Reply to Referee #3' s comments

Title: A flux tower site attribute dataset intended for land surface modeling

No.: essd-2024-77

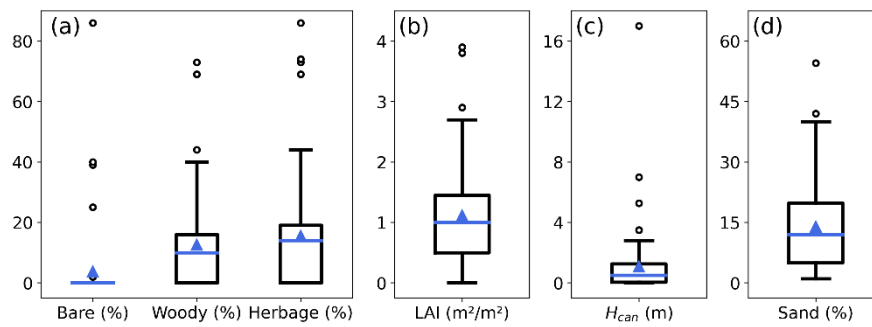
Comment 13 (L95): Were these PFT estimates cross-checked against site information e.g. from past papers? Global PFT datasets can be highly uncertain at flux towers even if provided at a high spatial resolution

Response 13: We completely agree with your suggestion. Other reviewers have raised similar concerns, indicating the need for cross-checking of filled data to quantify their uncertainties.

Accordingly, we have provided the quantification of uncertainties for the filled data. The discrepancies between site data and filled data have been added to Sect. 3.2, illustrating the uncertainties of the filled data. The added part is as follows:

Figure 4 quantifies the differences between site data and filled data at all sites for which both data sources are available, illustrating the inhomogeneities in the final dataset due to data filling. The differences in vegetation cover (including bare soil, woody, and herbaceous vegetation) generally fall within 20%, with a minority of sites exceeding 40%. The mean and median LAI differences are approximately 1 m²/m². Canopy height deviations are primarily within 2 m, although a few sites exceed 4 m. Differences in sand content typically remain within 30%, with both mean and median differences below 15%. This quantification indicates that the filled data are generally reliable across most sites.
